<u>MEETING</u> CHIPPING BARNET AREA COMMITTEE
<u>DATE AND TIME</u> MONDAY 19TH FEBRUARY, 2018 AT 7.00 PM
<u>VENUE</u> HENDON TOWN HALL. NW4 4BG

Title	Review of the Barnet Hospital Area Statutory Parking Consultation
Report of	Strategic Director for Environment
Wards	Underhill and High Barnet
Status	Public
Enclosures	<p>Appendix A –</p> <p>Drawing No. SCR191-2a - Proposed CPZ - Granville Road and Argyle Road EN5 (revised)</p> <p>Drawing No.SCR191-3a - Proposed CPZ – Elmbank Avenue, Garthland Drive, Vyse Close, Wellhouse Lane and Wellside Close EN5 (revised)</p> <p>Drawing No.SCR191 – 4a Proposed CPZ - Lingholm Way, Lexington Way and Sutton Crescent EN5 (revised)</p> <p>Drawing No.SCR191-5 - Galley Lane and Barnet Road</p> <p>Drawing No.SCR191-6 - Trinder Road, Well Road and Well Approach</p> <p>Drawing No.SCR191-7 - Bells Hill and Spring Close , St Stephen Road and Redwood Way</p> <p>Drawing No.SCR191-8 - Aitken Road, Denton Close, North Close, Escot Way and Endersby Road</p> <p>Drawing No.SCR191-9 - Kings Road and Cavendish Road</p> <p>Drawing No.SCR191-10 - Kings Road and Grimsdyke Road</p> <p>Drawing No. SCR191-11 - Bells Hill and Dellors Close</p> <p>Drawing No.SCR191-12 and SC

DRAWING NO:
SCR191-2a

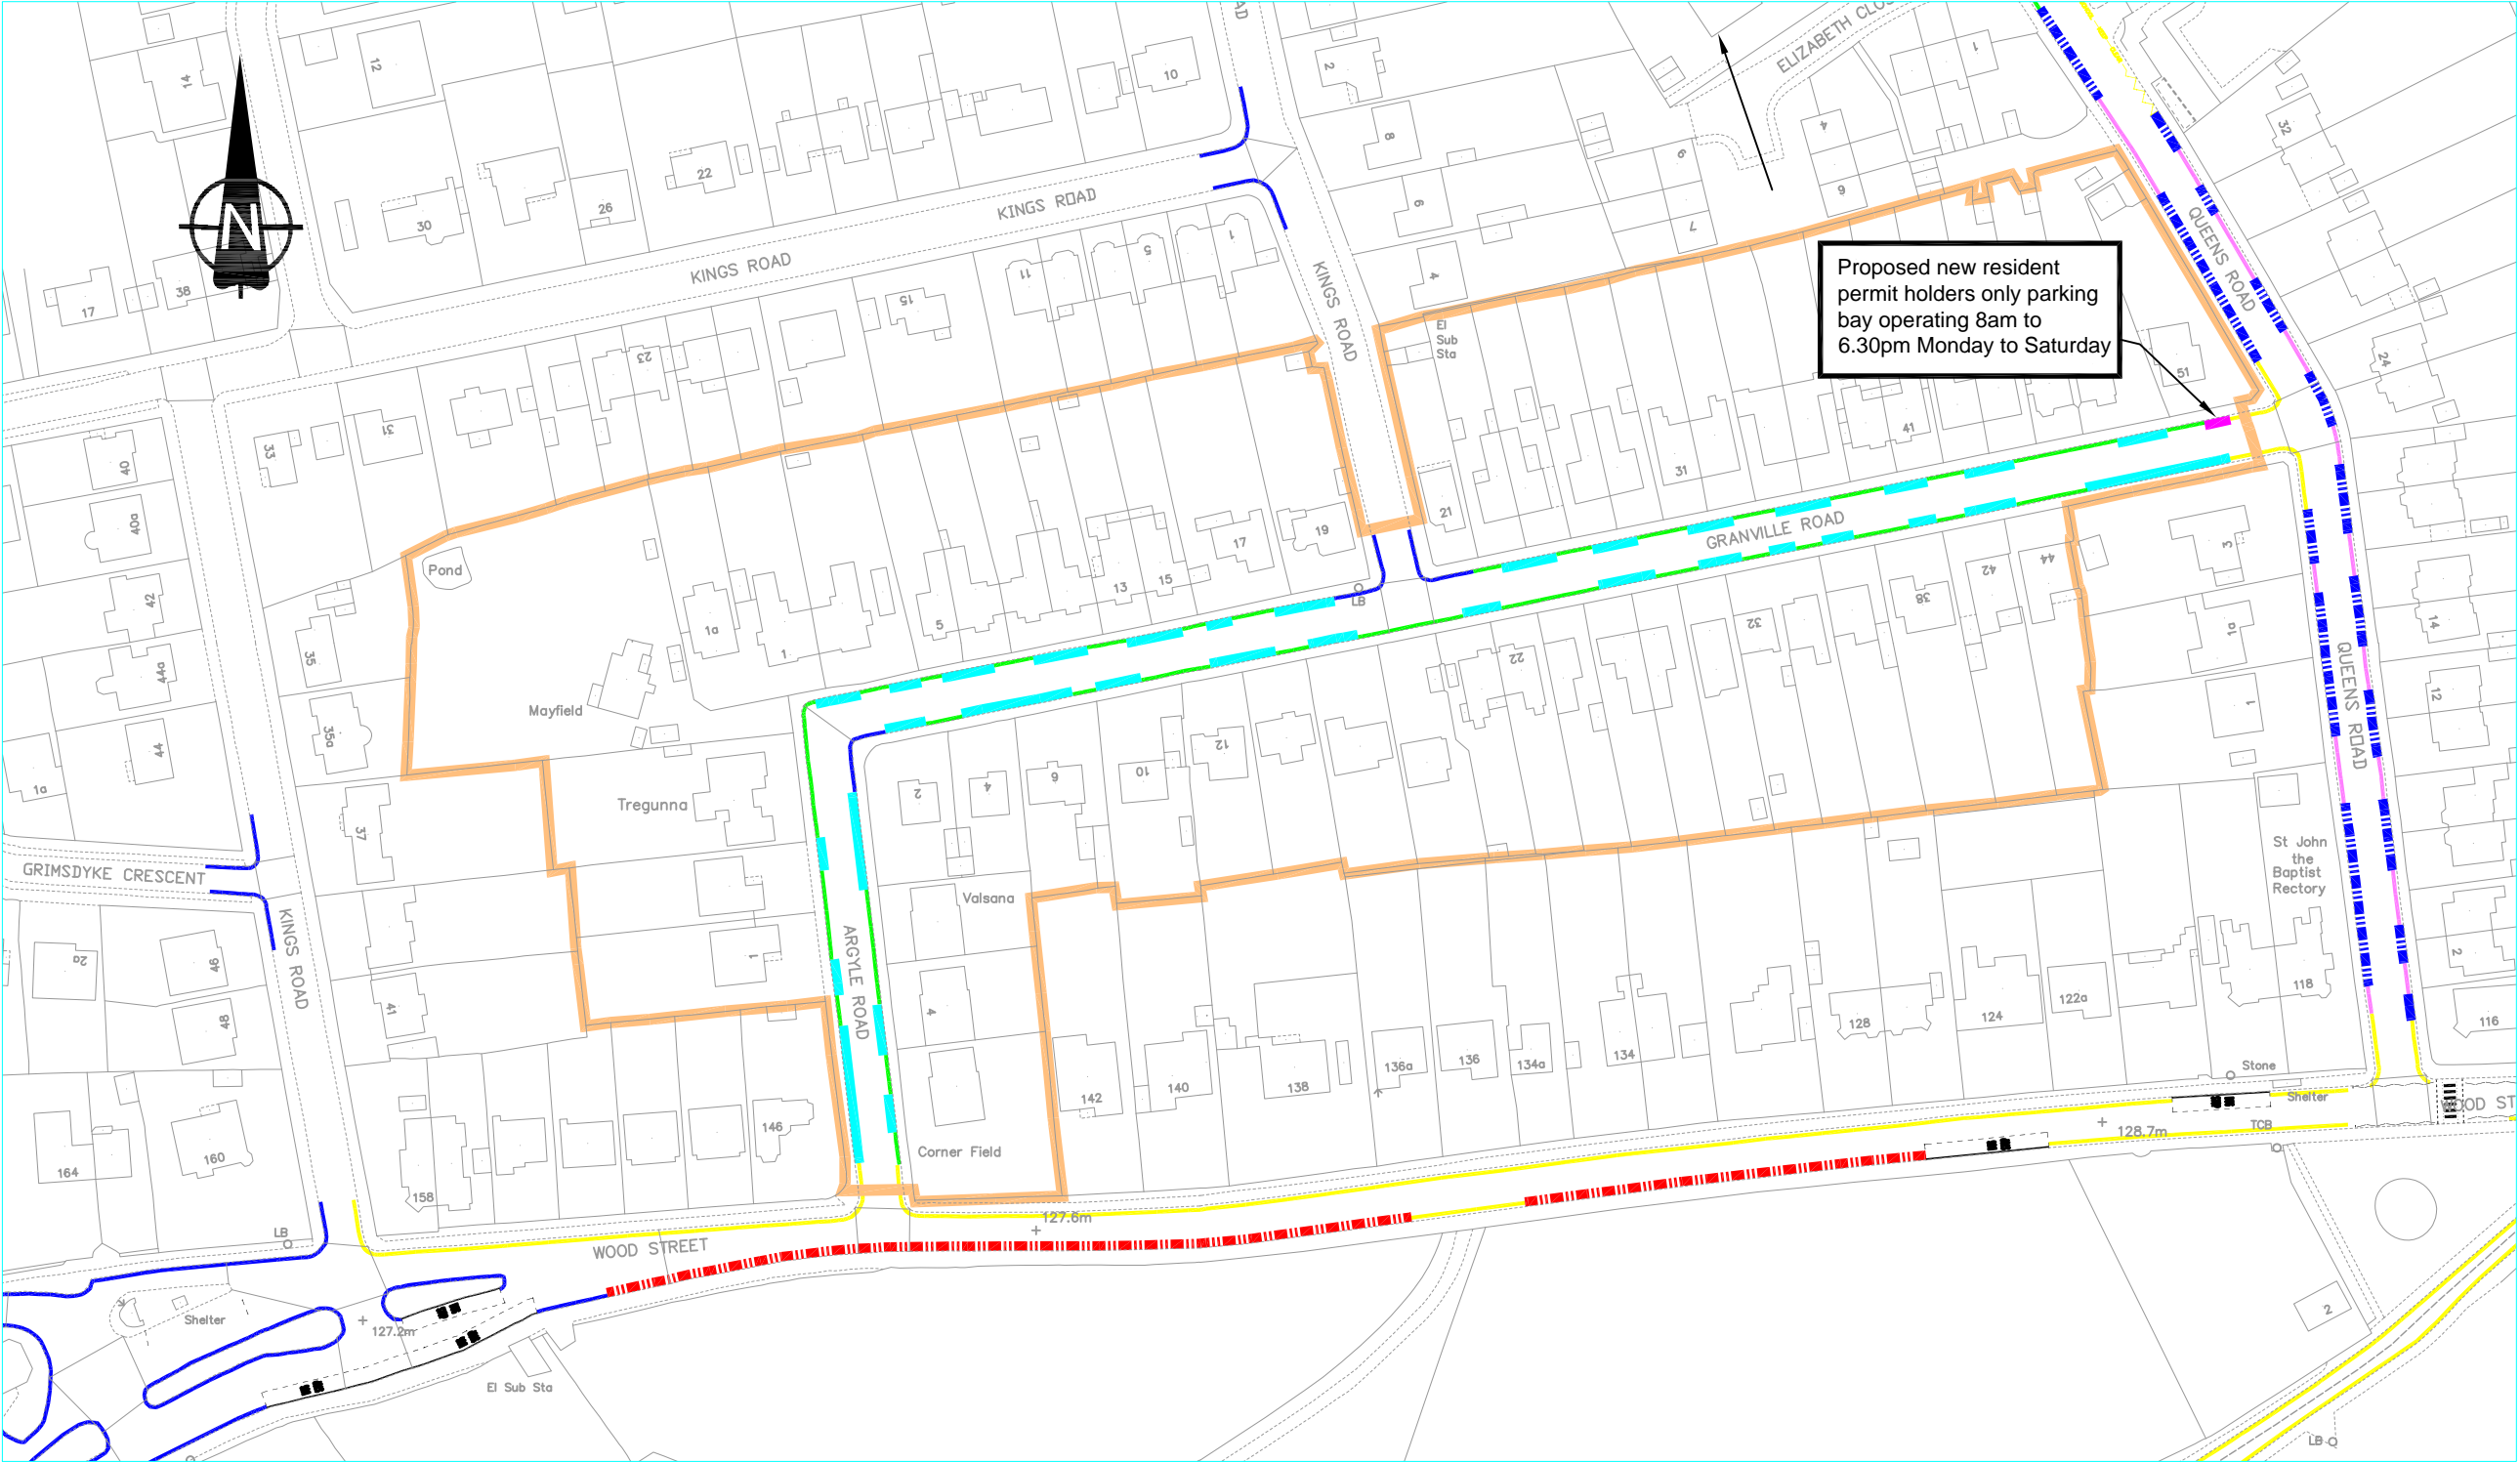
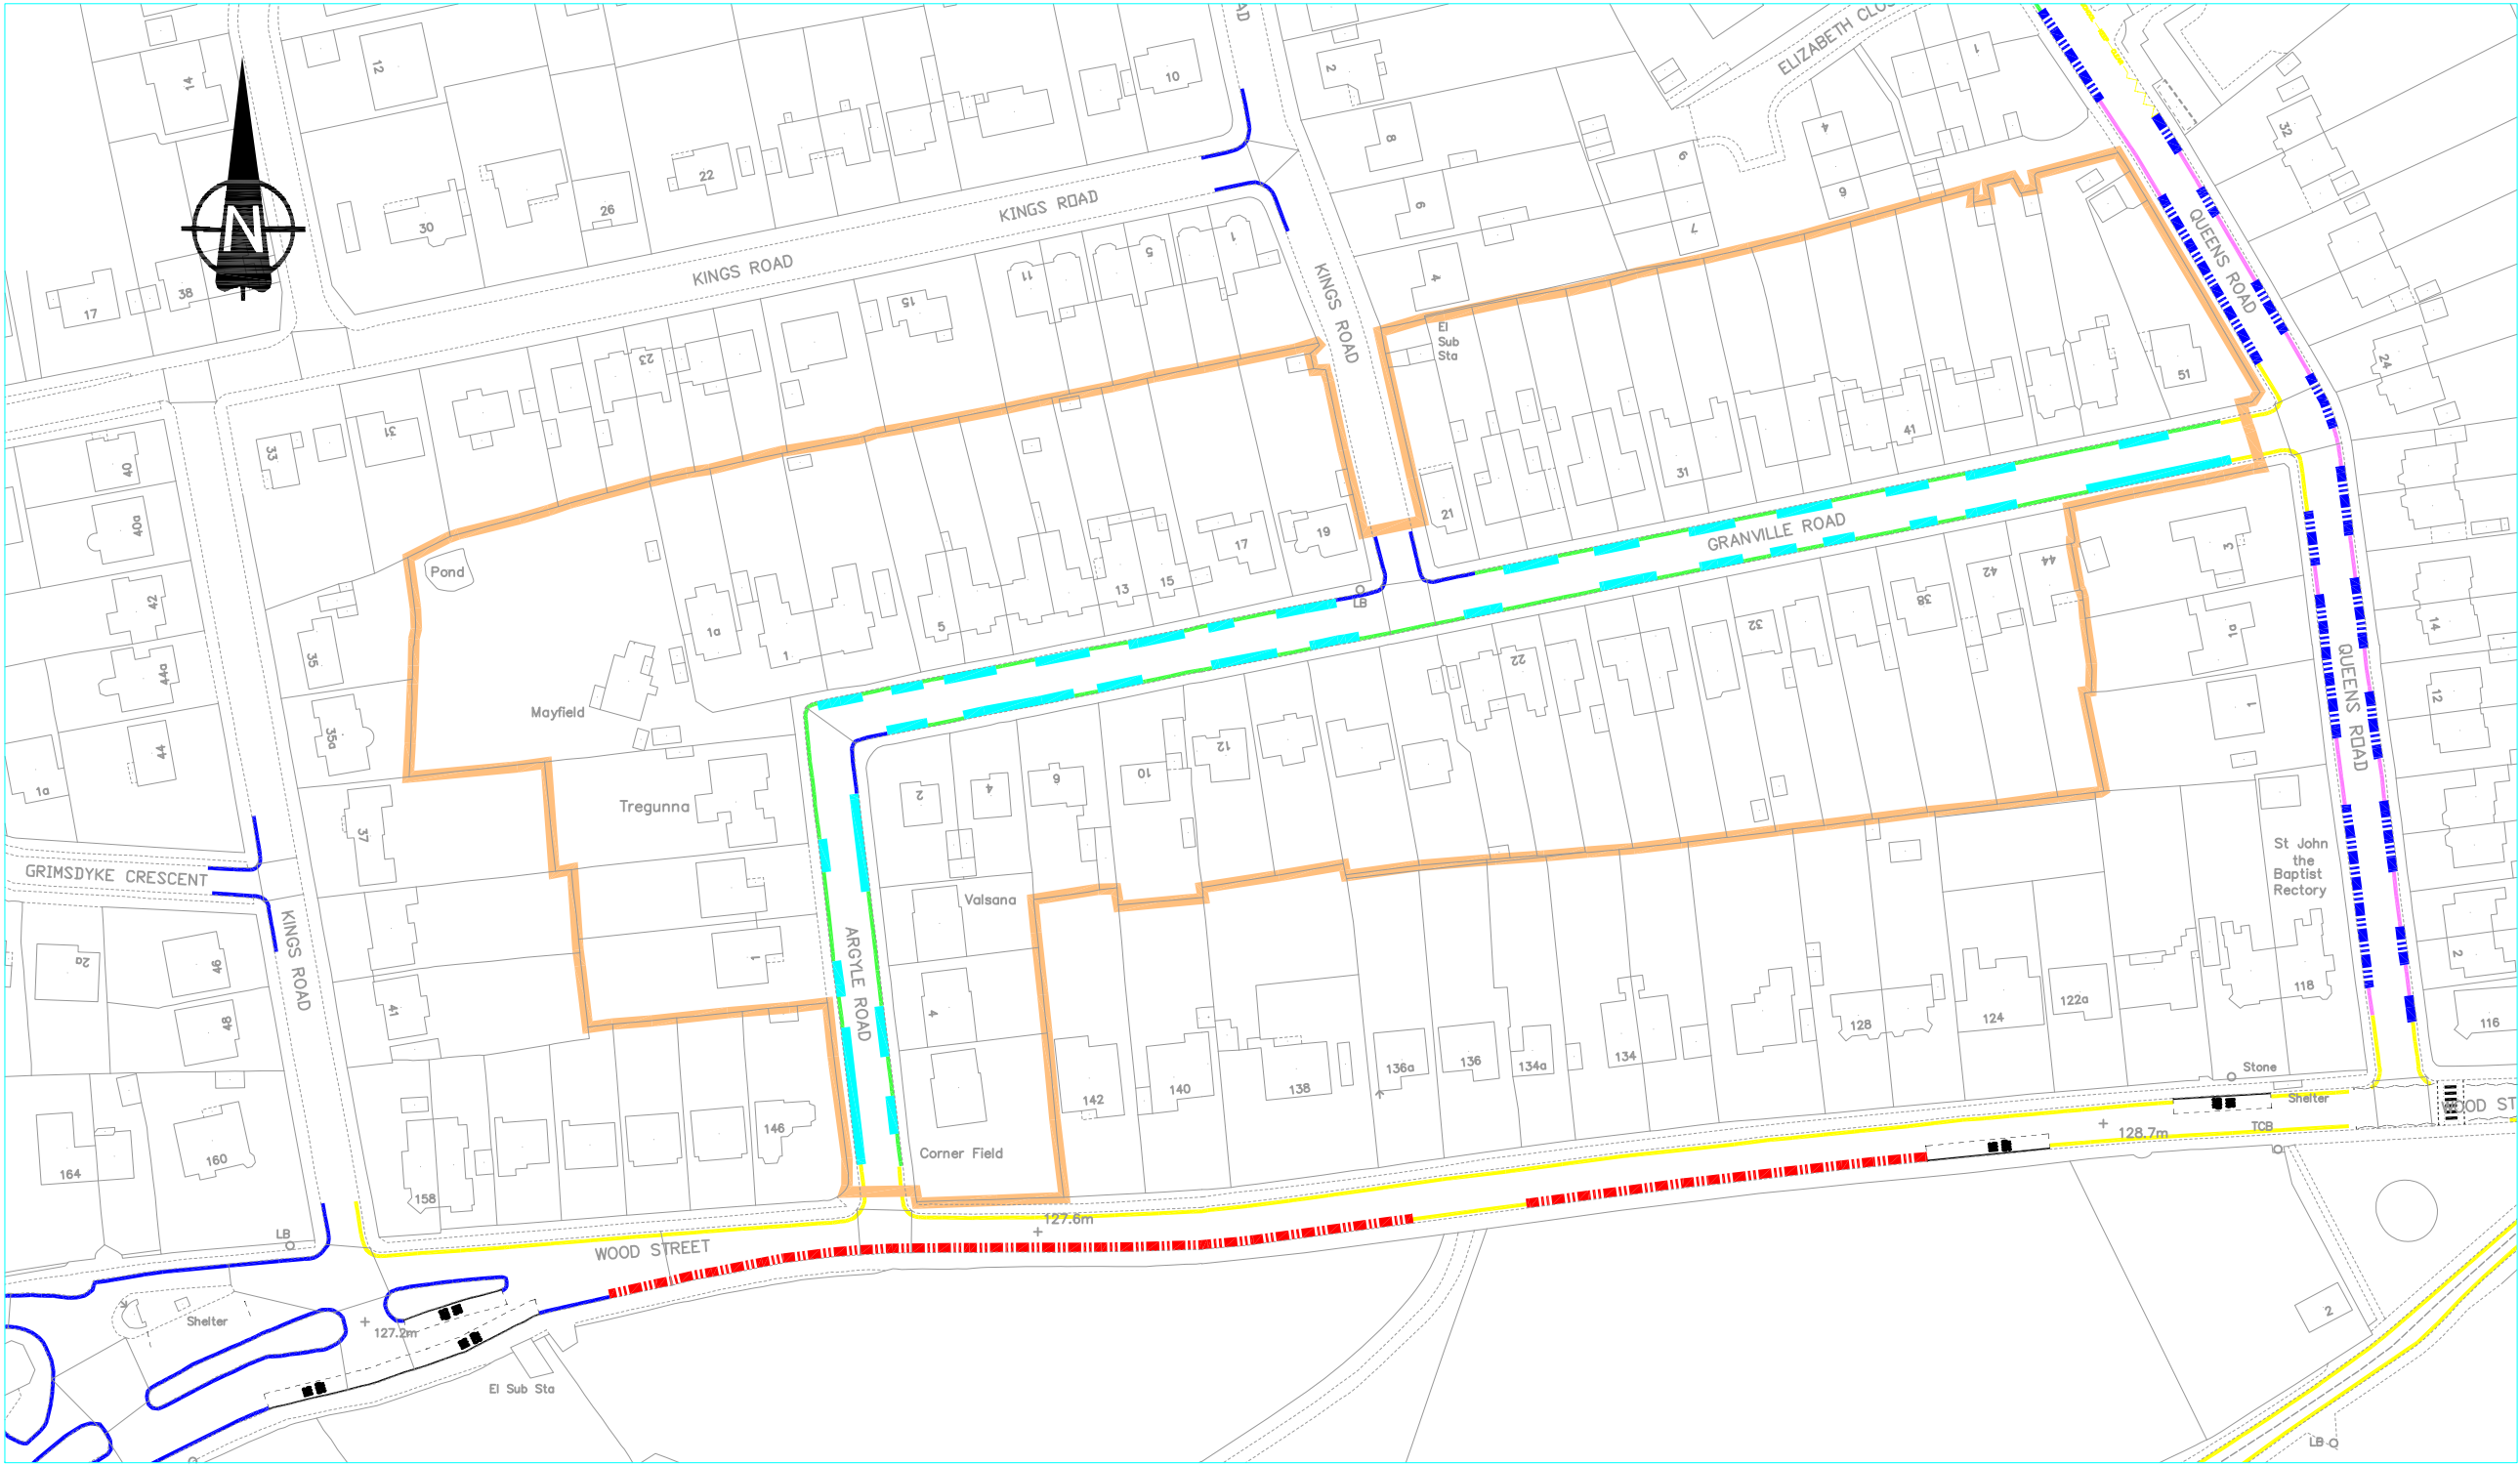
- 1.12.2 In response to the consultation the Council received 17 items of correspondence and an overview of the comments are shown below:
- 1.12.3 Two residents of Granville Road requested for additional resident permit holders only parking spaces on street outside their houses.

- 2.13 It is considered that an additional resident's permit parking place should be introduced outside No. 51 Granville Road.
- 2.14 It is considered that the proposal should be implemented albeit with minor modifications as outlined above and as shown on plan SCR191-2a

- b. That an additional parking place should be provided on Granville Road outside No.51 Granville Road – Drawing No.SCR191-2a.**
 - c. That the proposed resident parking bays on Sutton Crescent outside No. 41 and No. 43 Sutton Crescent , outside No. 47 and No. 49 Sutton Crescent and outside No. 51 and No. 53 Sutton Crescent are converted to “At any time” waiting restrictions. – Drawing No.SCR191-4a.**
